ADDENDUM NUMBER 1

DATE: 05/12/2025

PROJECT: City Hall Restroom Renovation

PROJECT NUMBER: 0100-0569

A411

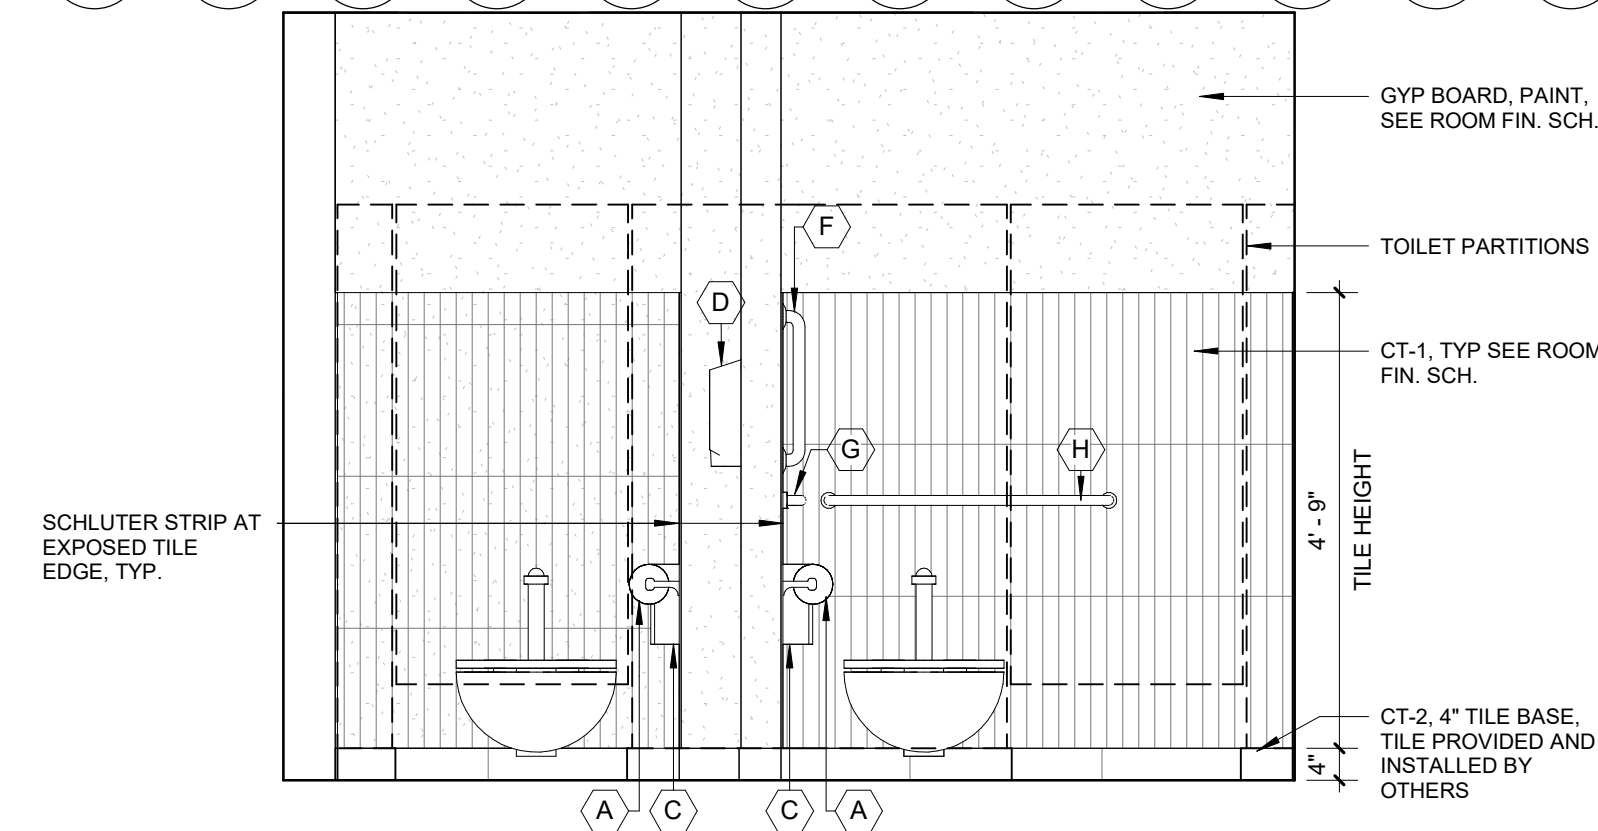
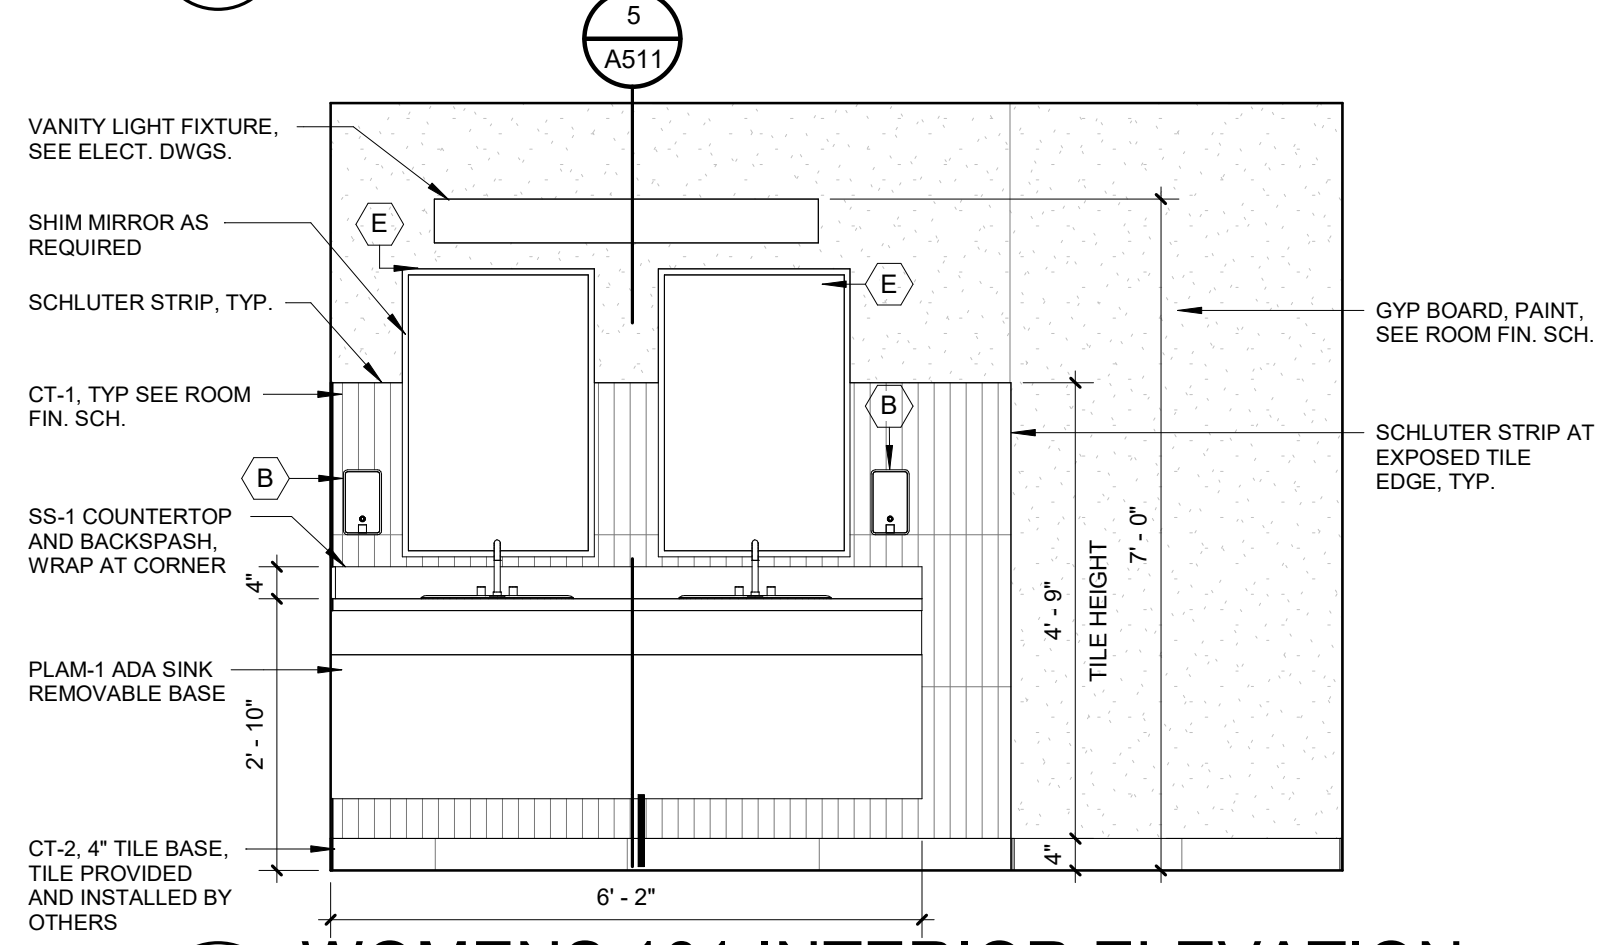
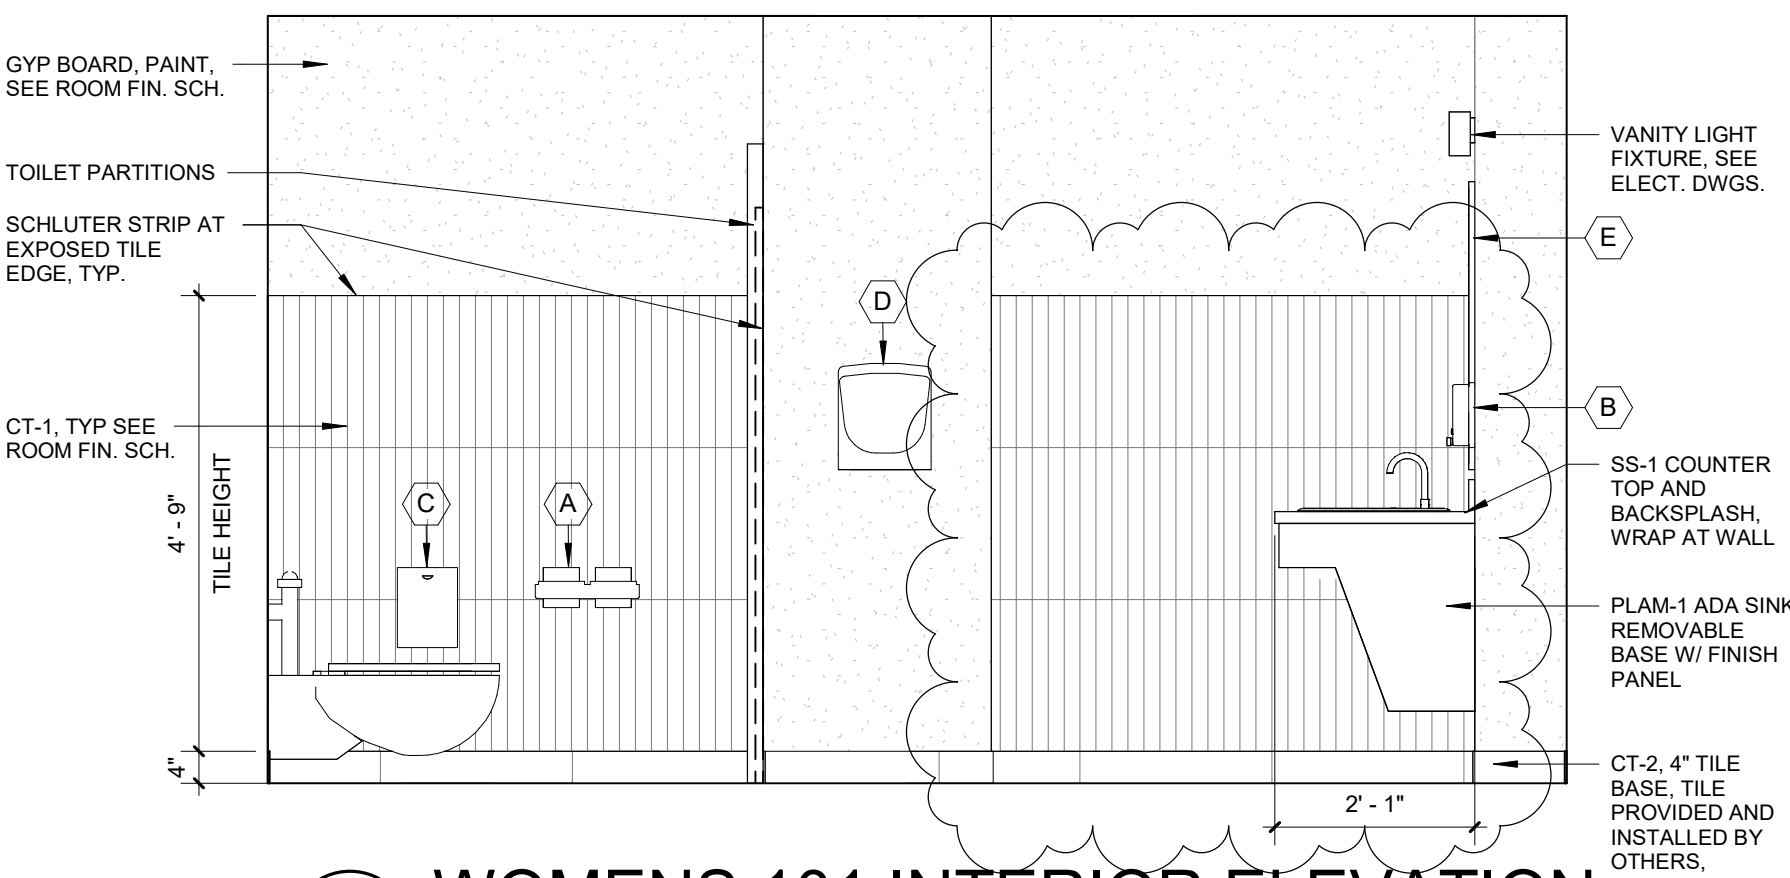
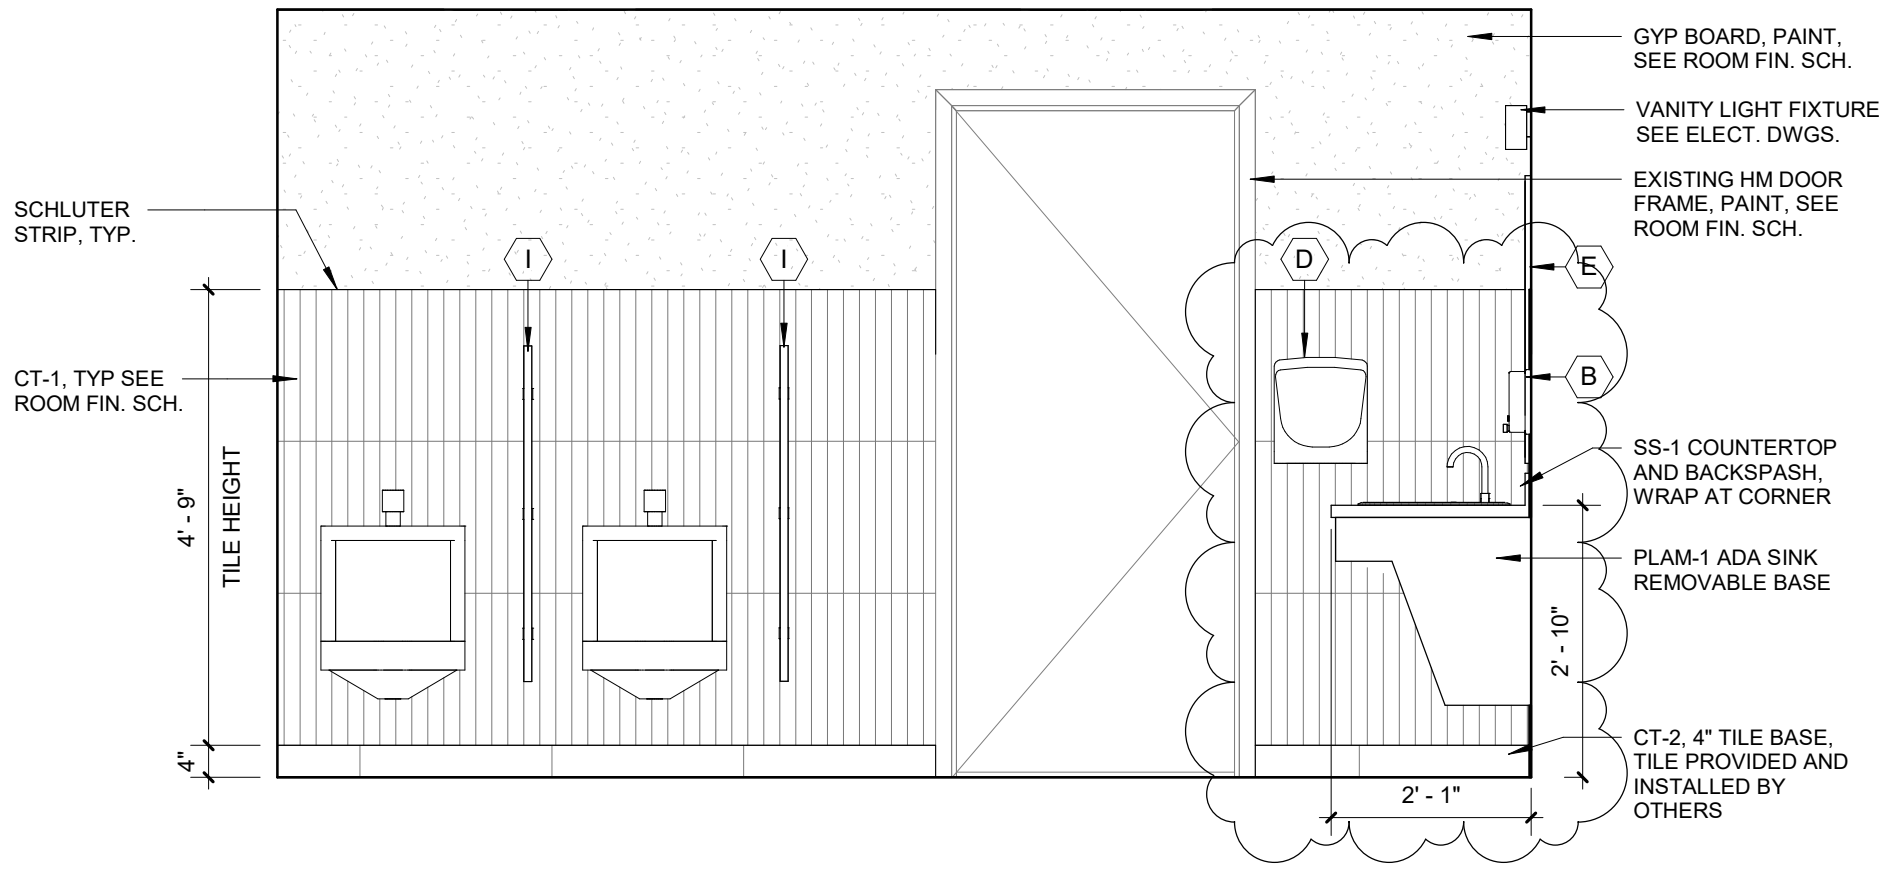
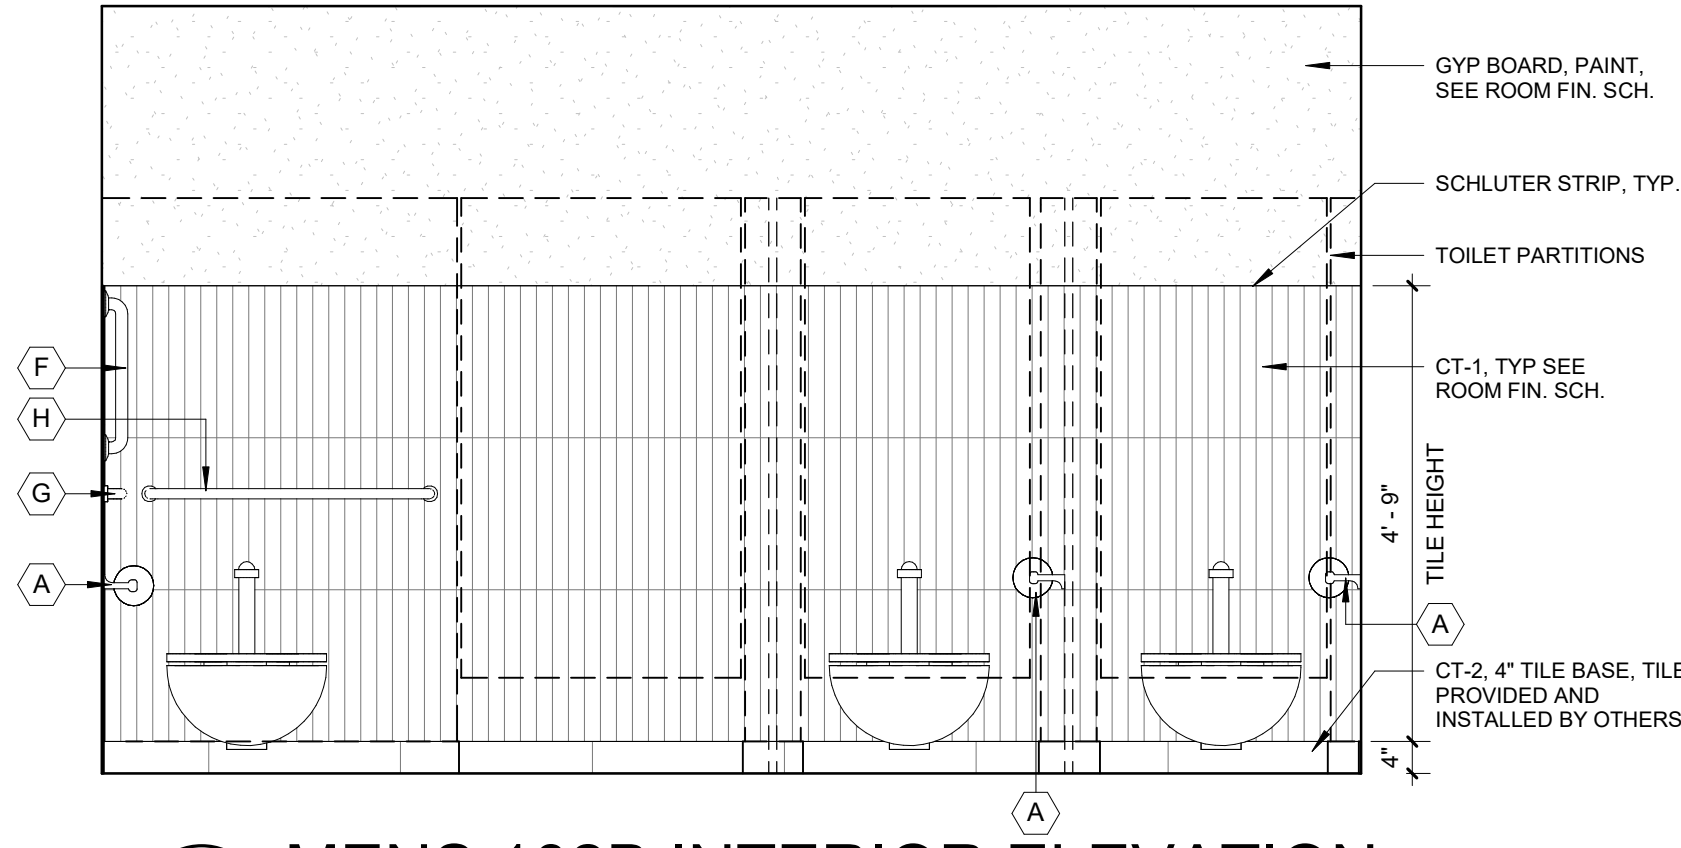
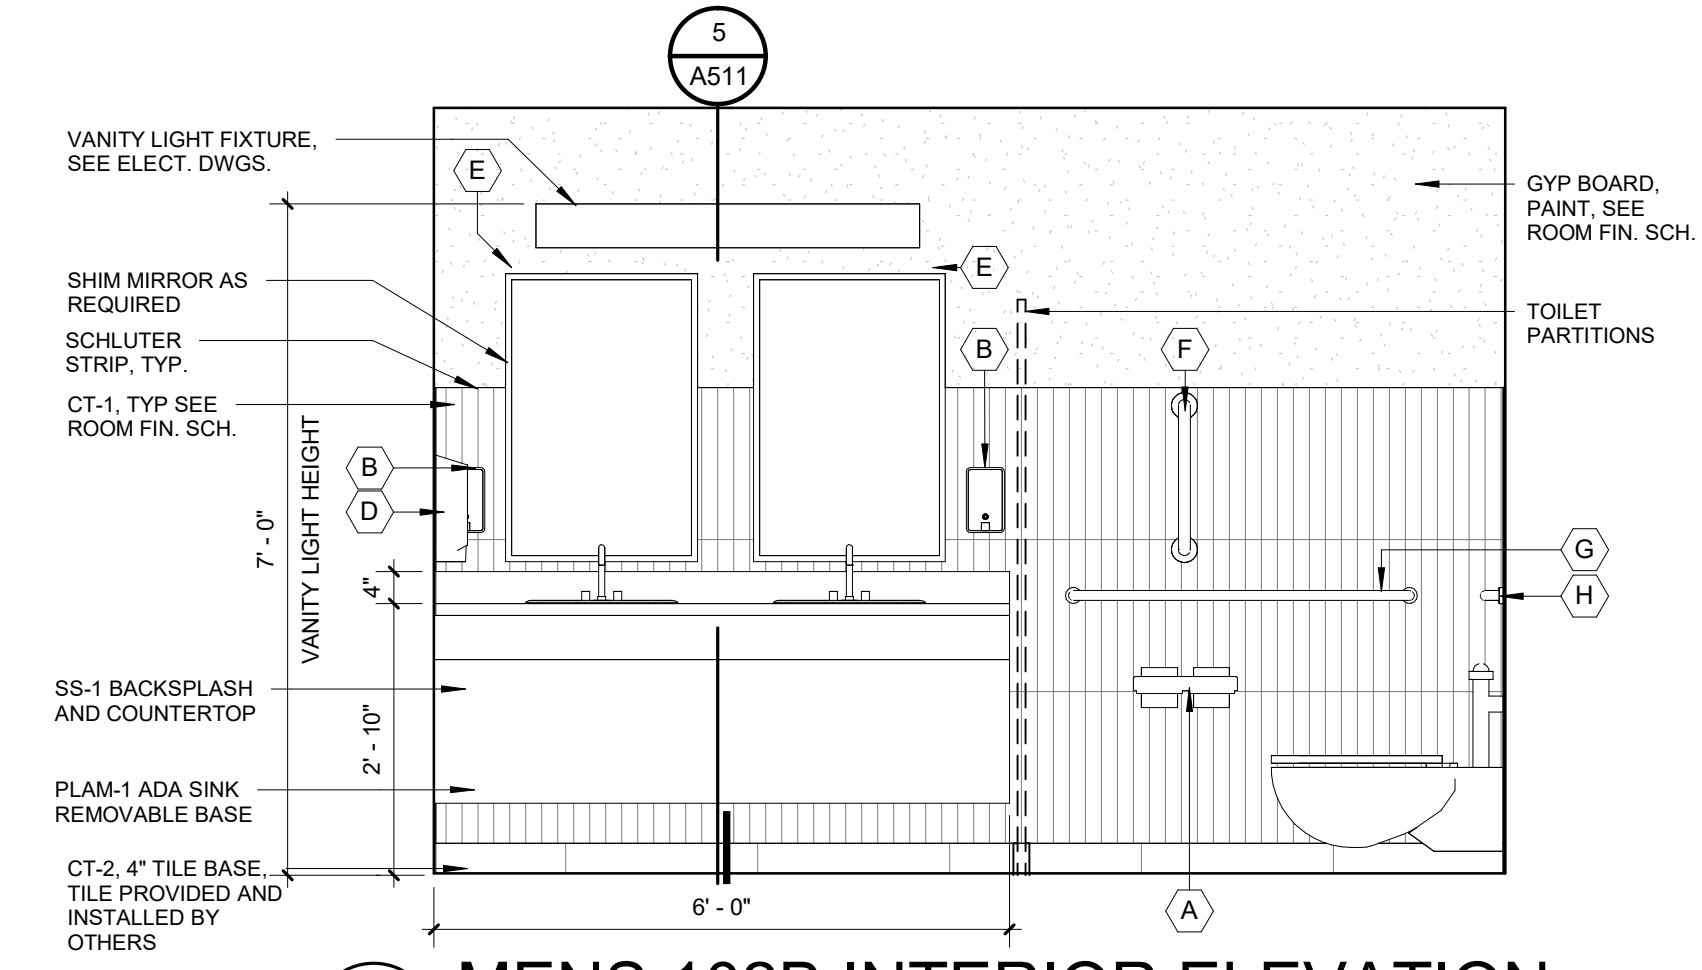
- e. Added stud wall to square off toilet partition in Women's 101
6. SHEET A411 : reissued
 - a. Added 4/A411 and 9/A411
 - b. Revised view number of 8/A411

- c. 7/A411: Tile extended
 - d. 1/A411: Tile extended
7. SHEET A412: issued
 - a. New sheet
 - b. Added 3/A412, 4/A412, 6/A412, 7/A412 interior elevations
